**Subject :** Submission of point wise reply raised by Hon'ble EAC during 13<sup>th</sup> meeting of Expert Appraisal Committee (Infra-2) for Projects related to All ship breaking yard including ship breaking unit, Airport, Common Hazardous Waste Treatment, Storage and Disposal Facilities, Ports and Harbours, Aerial Ropeways, CETPs, Common Municipal Solid Waste Management Facility, Building/Construction Project, Townships and Area Development projects held on 23<sup>rd</sup> - 25<sup>th</sup> January, 2017 for the Proposed Residential and commercial development of Sunberry at Plot No. -26, Sector- 8, Ghansoli, Navi Mumbai, District, Thane, Maharashtra by M/s. Neelkanth Infratech Co. -Environmental Clearance [F.No.21-95/2016-IA-III][IA/MH/MIS/60828/2016] listed as item number- 13.3.19

With reference to the above subject of 13<sup>th</sup> MoM of EAC, M/s Neelkanth Infratech Co. Project Sunberry is located at Plot No. 26, Sector-8, Ghansoli, Navi Mumbai and We hereby submitting point wise reply:

संमत सीमांकन नकाशा  
 वारिष्ठ नियोजनकार याचे पत्र क्र. सिडको/निजो/2016/1904 दिनांक 25/10/16

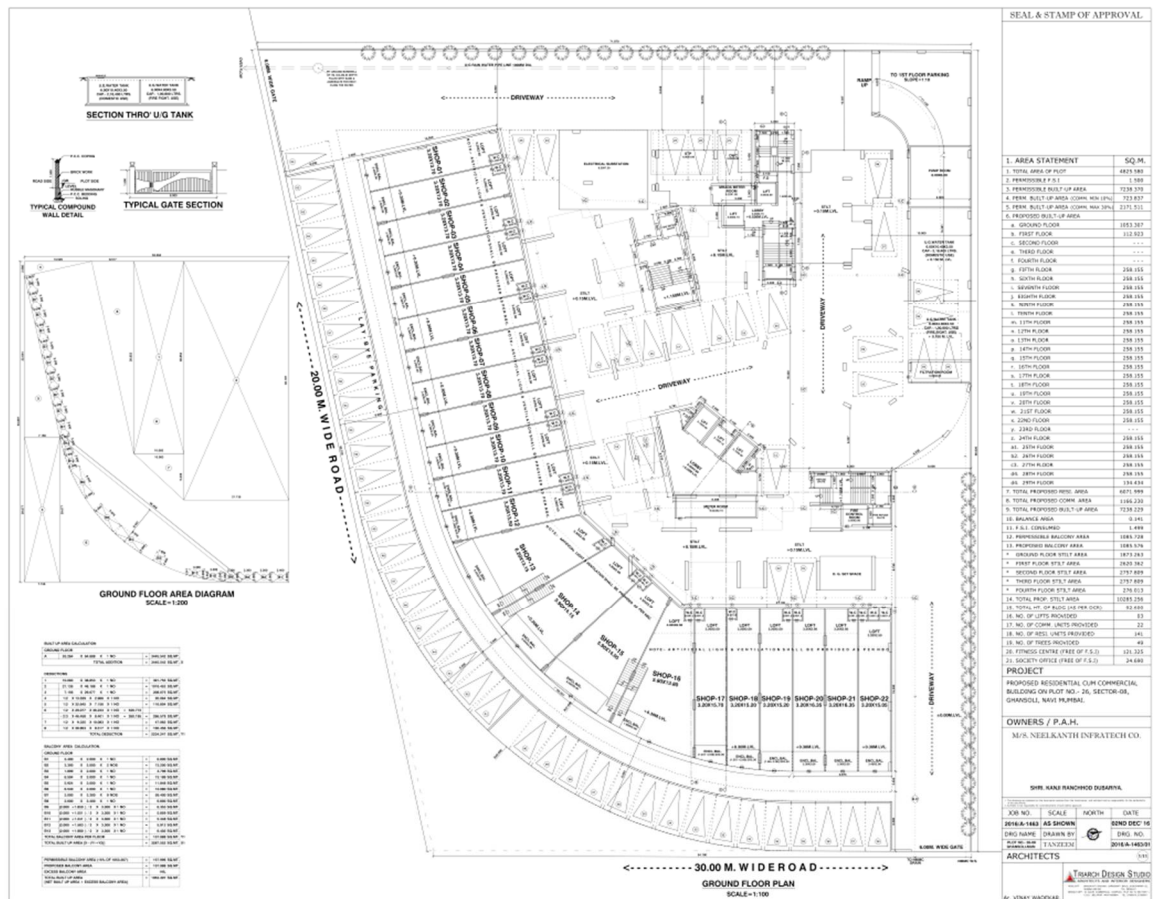
i.	Land use of the propose project site.  <b>Compliance:</b> As per the Sanctioned Demarcation Plan, present land use of the proposed project site for residential Purpose.  Please refer the Enclosure No. 1.
ii.	Copy of approved Sanction plan. Approval of the project from High Rise Building Committee of Maharashtra. <b>Compliance:</b> Please refer Enclosure No. 2 for proposed building sanction plan and application copy to Navi Mumbai Municipal Corporation for High Rise Committee approval dated 1 <sup>st</sup> march 2017. Since, High rise committee approval is still in process due to delay at the committee level, hereby we request you to consider our project and recommend for environment clearance on subject to receipt of High Rise Committee approval and on receive we will submit the receipt.

Enclosure 10: Solar Panel Layout

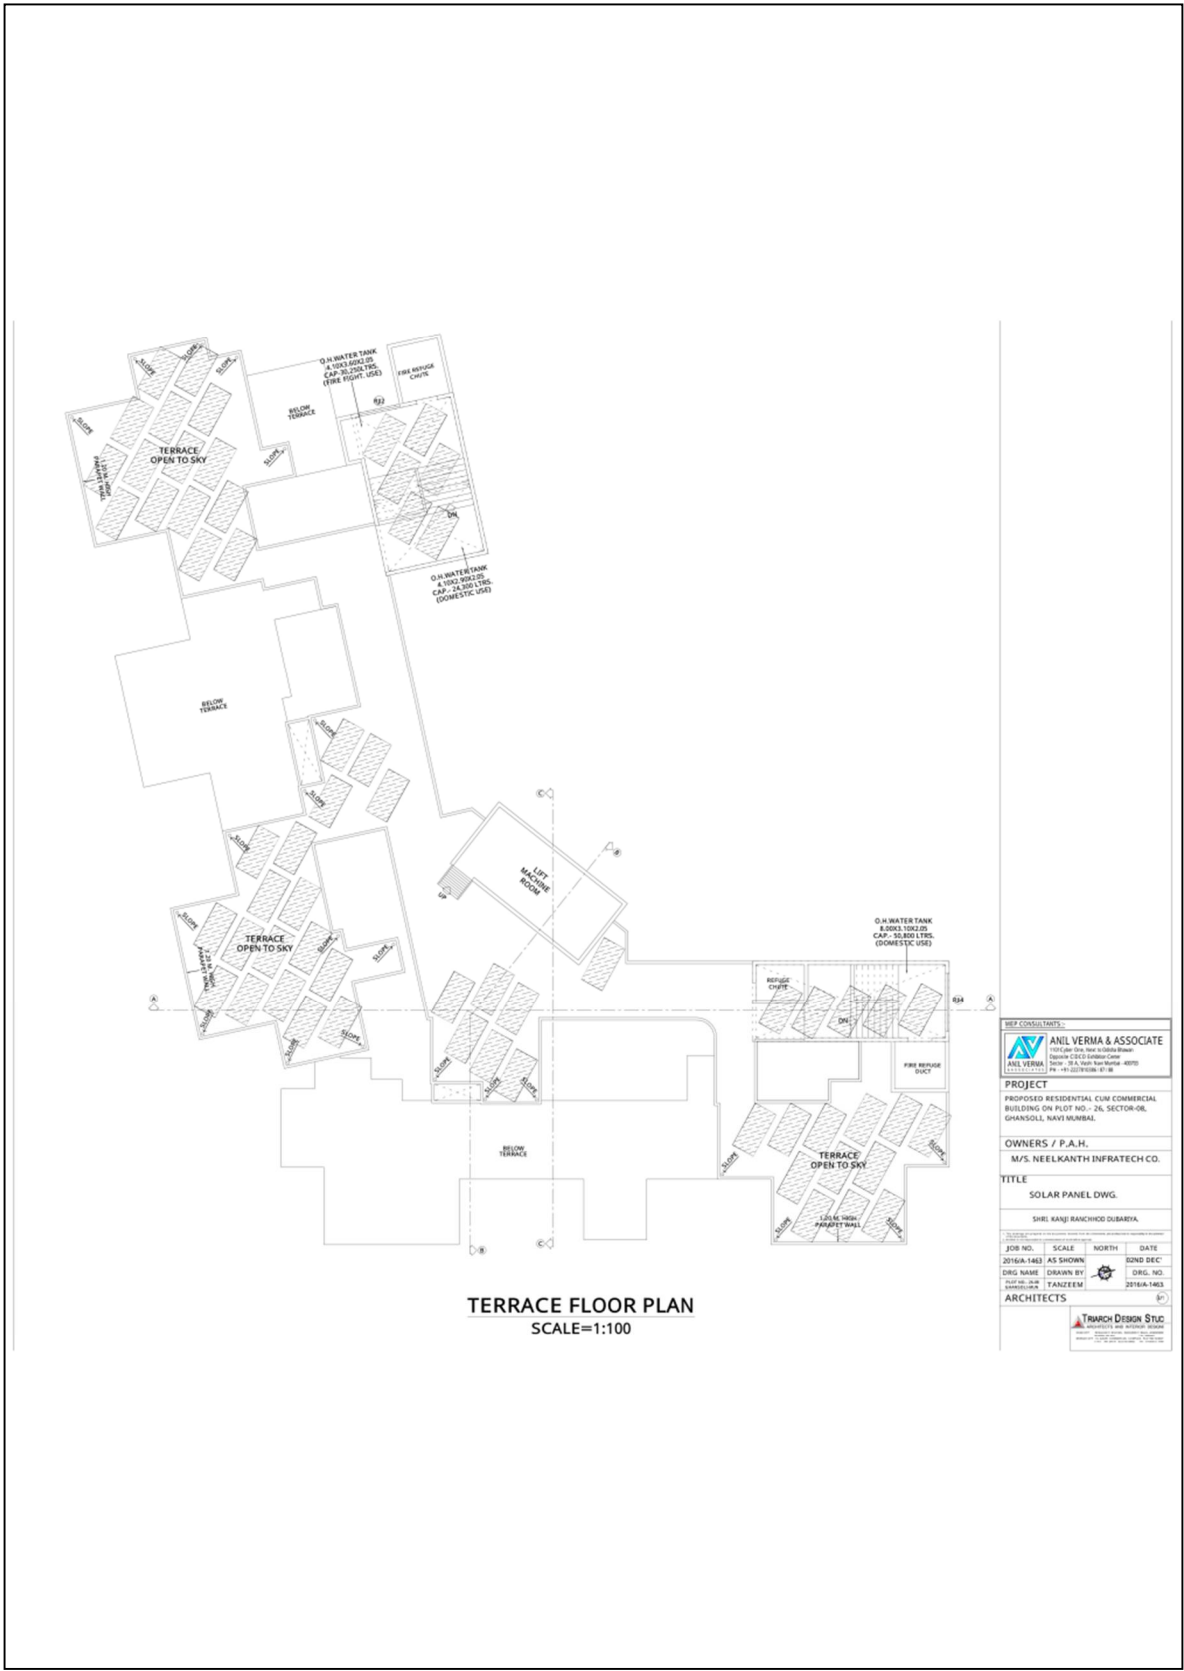
ix.	<p>At least 2 solar powered lights and one fan shall be provided in each flat. Solar Generation shall be connected to the grid.</p> <p><b>Compliance:</b> We already complied with the same. Kindly refer Enclosure No. 9 for energy conservation via solar energy. Kindly refer Enclosure No. 10 for solar panel layout.</p>

Enclosure 12: Landscape plan on Ground and fourth floor podium

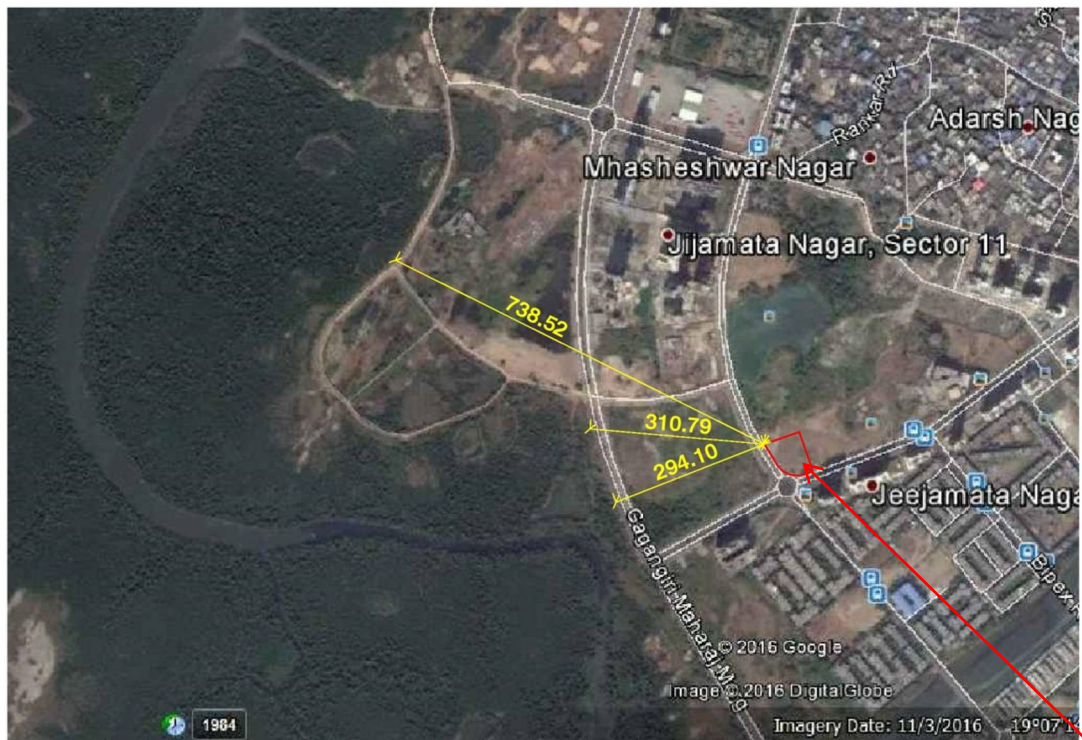
xii.	<p>Increase the area for greenbelt. Layout plan indicating Greenbelt along with area Earmarked to be provided.</p> <p><b>Compliance:</b> We have assessed the possible green area on ground floor and provided as possible on ground- 483.567 Sq. Mt. and on podium floor- 500.584 Sq. Mt. Kindly refer Landscape layout plan on ground and podium as Enclosure No. 12.</p>
